**Subject:** Submission on Ballinlee Green Energy case no 323780

**Re: ABP case reference : PC91.320745**

**Applicant: Ballinaslee Green Energy limited**

Ballinlee Windfarm layout  
Horizontal separation distances between turbines

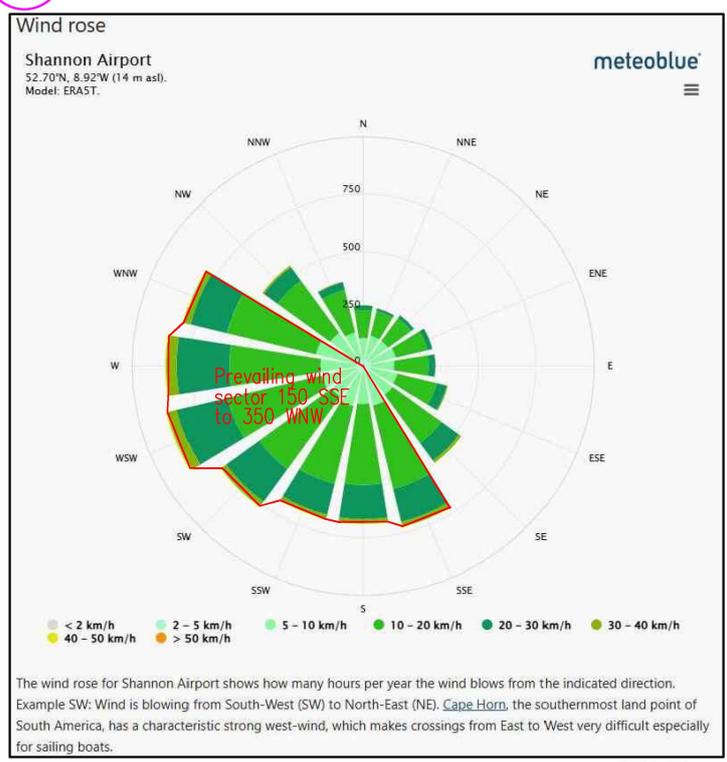
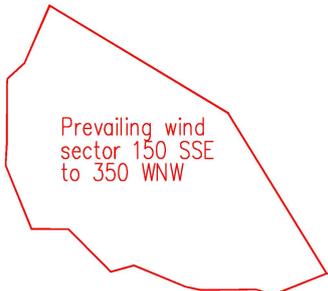
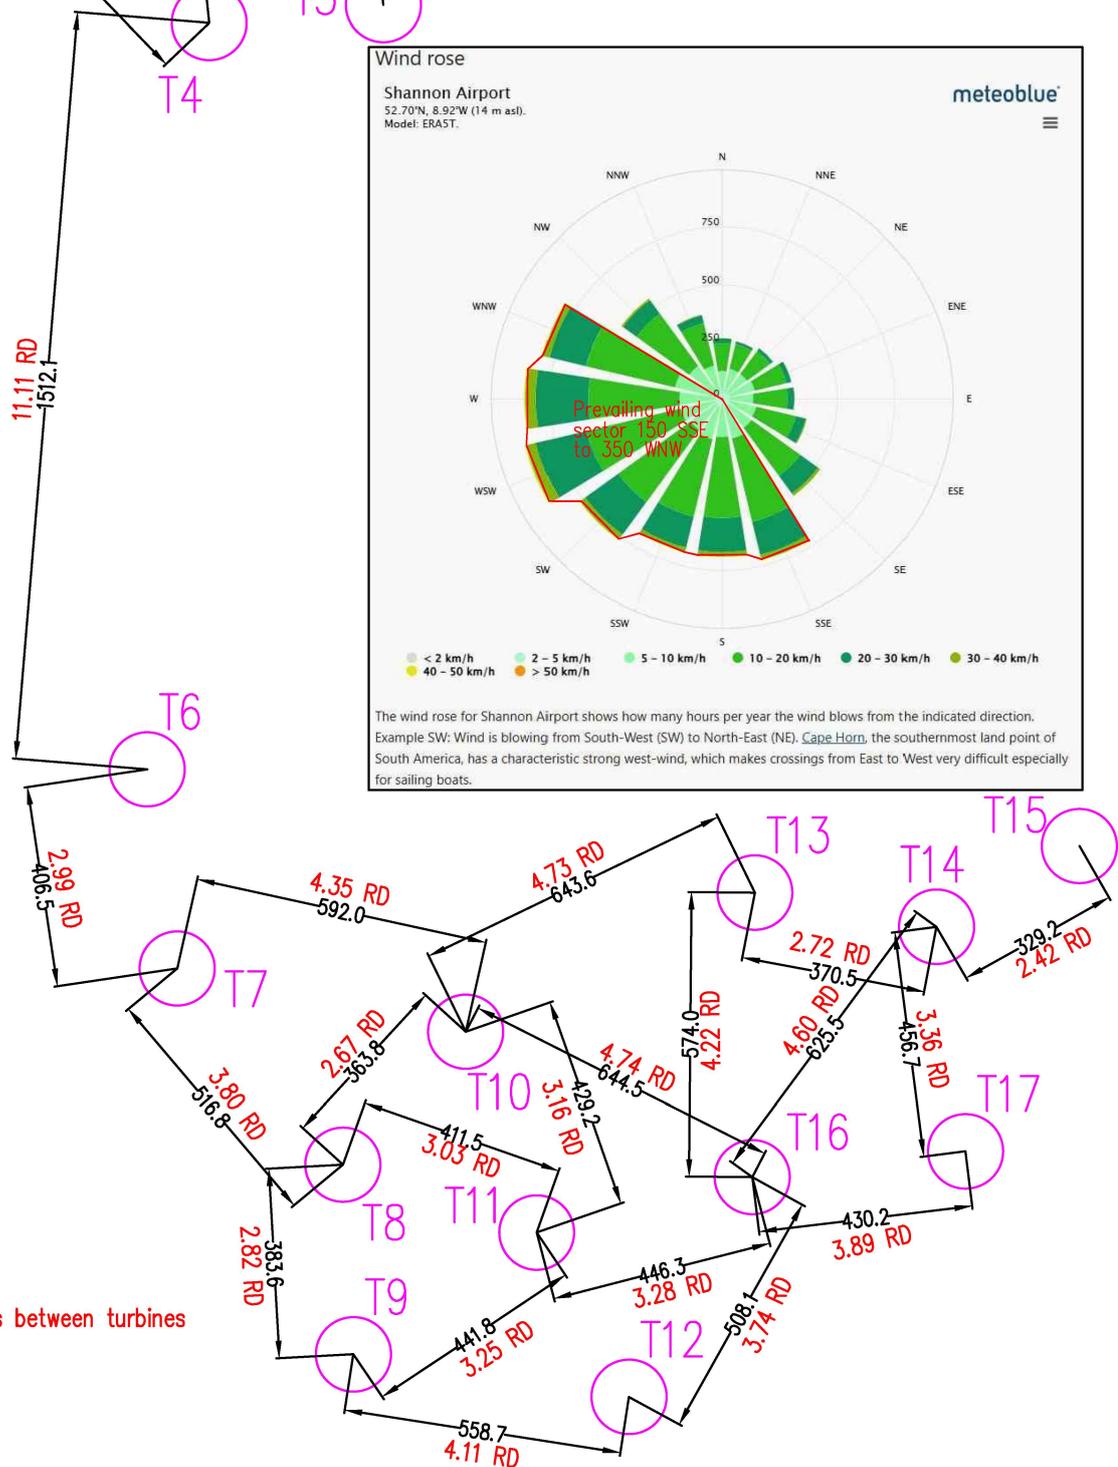
In ABP case reference **320745** to which this observation refers, the applicant has, as one can see in Map 1, (next page) ignored the turbine separation distances from adjacent turbines, that are recommended in the WEDG2006 guidelines.

It should be noted that the prevailing winds, those requiring 7 rotor diameter separation distance between turbines are not only from the southwest direction. Map 1 shows that in reality there are significant winds of significant duration from 150 South-southeast to 350 North-northwest.

Therefore the positioning of all turbines are in prevailing wind direction’s relative to each other. This then says that all turbines should be a distance of 7 rotor diameters apart per the WEDG2006 guidelines and 5 rotor diameters per the Manufacturers guidelines.

Map 1 shows that the spacings between T1 to T4 and T4 to T6 are the only pairings that have the recommended spacings per WEDG2006 guidelines.

All other spacings are sub-standard and will, in my learned opinion, cause noise nuisance similar to the Meenacloughspar (Ballyduff) and Gibbett hill windfarm cases that have been established in the courts.

It is my opinion that the developers will not get a valid warranty for the eventual turbine, after their tender process, for a spacing less than 5 rotor diameters in the prevailing wind direction and 3 rotor diameters in other directions. The layout on Map 1 shows a significant lack of spacing, using the manufacturer’s recommendations and a serious lack of spacing relative to the WEDG2006 guidelines.

WEDG 2006 says 7 rotor dia (RD) in prevailing wind and 3 rotor dia. in crosswind between turbines.

Therefore at least some turbines must be 952m apart at a minimum in the prevailing wind and no turbine shall be within 408m of another turbine..

Turbine manufacturer says greater or equal to 5 rotor dia in prevailing wind and greater or equal to 3 rotor dia. in crosswind between turbines.

Therefore at least some turbines must be 680m apart at a minimum in the prevailing wind and no turbine shall be within 408m of another turbine..
